Our Northern Runway: making best use of Gatwick

Highway Improvement Changes and Project Update

CONSULTATION DOCUMENT

Summer 2022

Figure 2.2 Plan showing part of the revised Project site boundary

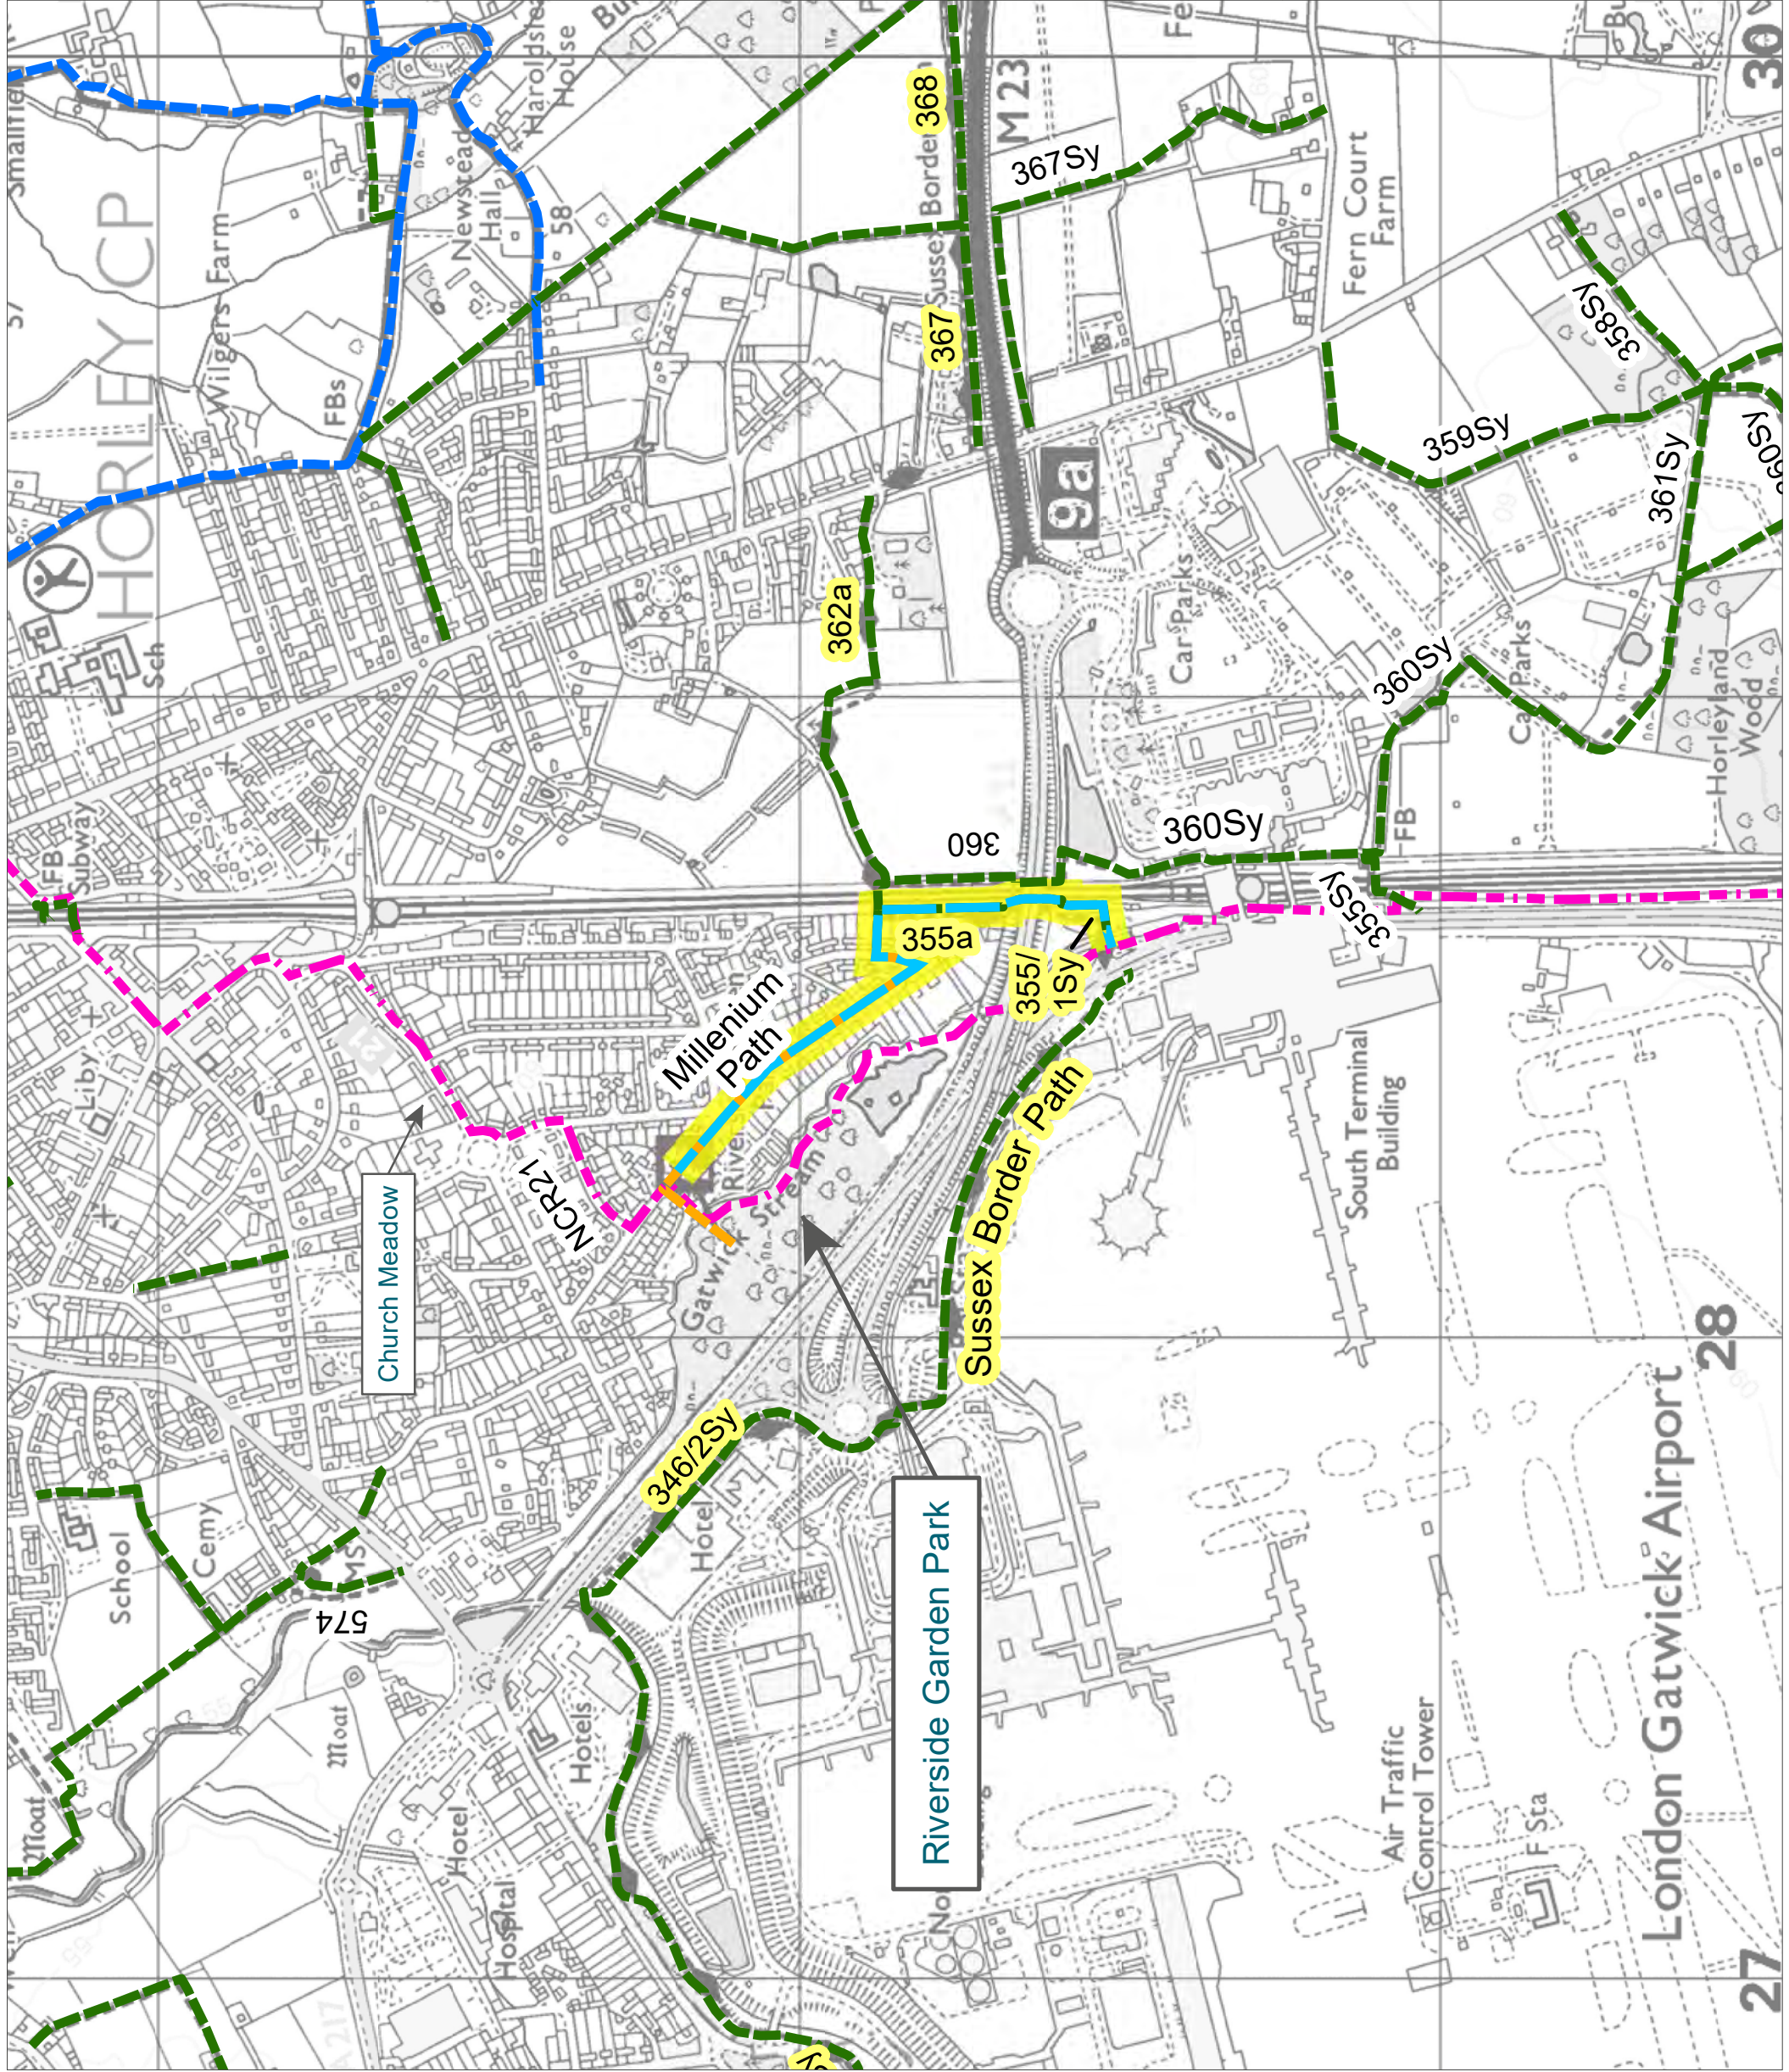
- 2.1.3 The PEIR included a figure identifying the surface access improvements (this was Figure 5.2.1d of the PEIR). Figure 2.2 provides an updated figure showing part of the revised Project site boundary as a result of the highway improvement changes.
- 2.1.4 There are diversions proposed for public rights of way and a National Cycle Route and these are shown in Figures 2.3a to 2.3d.
